Arklow LPF Variation No.5

Variation No. 5 to the County Development Plan 2022-2028

Arklow Local Planning Framework

Arklow Town Centre "divided" into level of activity.

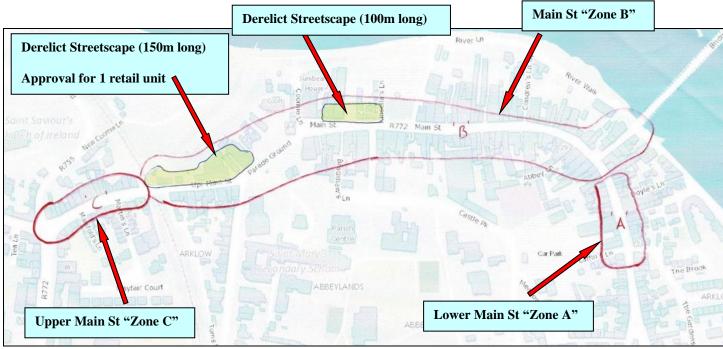
I include the following map where I have broken the town centre into 3 distinct zones and provided a breakdown of commercial activity.

Providing a smaller more condensed retail core would present a positive approach to,

- 1. Improve the vibrancy to the town centre
- 2. Provide much needed residential properties in a housing crisis on the periphery of the town centre.

This would promote town centre living and a sustainable use of existing building stock.
- 3. The proposed development would significantly improve the vitality and viability of Upper Main Street by facilitating a mix of uses and activities all of which help enhance the overall character of the town centre.

2025 Arklow Local Framework Arklow Retail Core Area Map

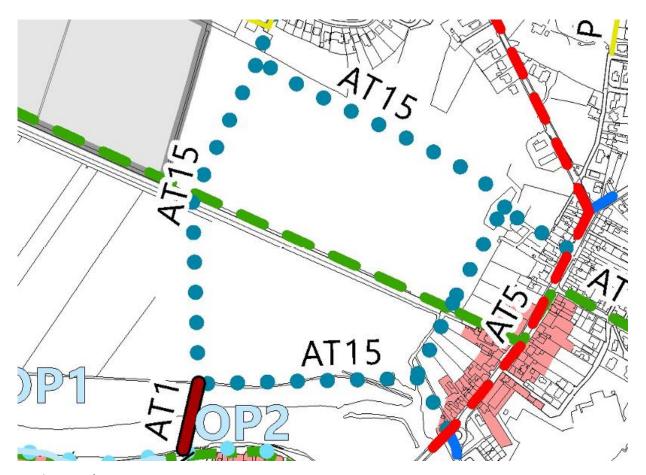
Please note the following anomalies with the current retail core map:

- The retail core of Arklow is the Bridgewater shopping centre and despite this, it is not included in the retail core zone map.
- The current retail core map has <u>excluded Lower Main Street</u> from the retail core zone in 2022, despite
 the fact it has a higher proportion of commercial street level units than Upper Main Street and is a far
 busier and active commercial part of town.

- The above figures highlight that the current retail core map is seriously flawed when Lower Main street is excluded and Upper Main street is still included. It is common knowledge that Lower Main street is a more commercially viable part of the town centre with more activity and footfall.

- There are 34 properties located on Upper Main Street between the railway line and the roundabout to the wexford road and the above table highlights that 44% are residential confirming that this part of the town centre has a larger residential/commercial mix compared to the town centre retail core section of main street where over 94% of street level properties are commercial.

The retail core map for the town should be reduced in size and extend from Bridge St to the railway bridge on Upper Main St only.
